Comments re: San Diego, Yuma, El Paso Make Safe Activities--<u>El Paso Sector</u> Remediation Plan 2023

Thank you for this opportunity to comment on the proposed activities that include remediation damage and unsafe conditions caused by construction of the pedestrian barriers along the New Mexico-El Paso/Mexico border on behalf of the local chapters of Great Old Broads for Wilderness and the Sierra Club.

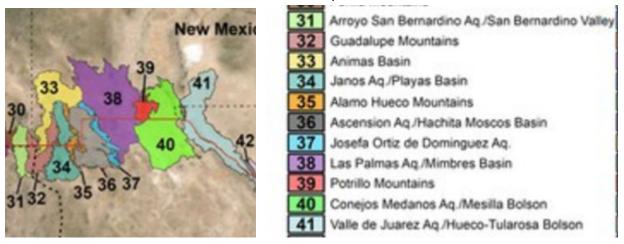
Reuse rocks and soil already excavated from prior construction as your source for rip rap and for soil remediation.
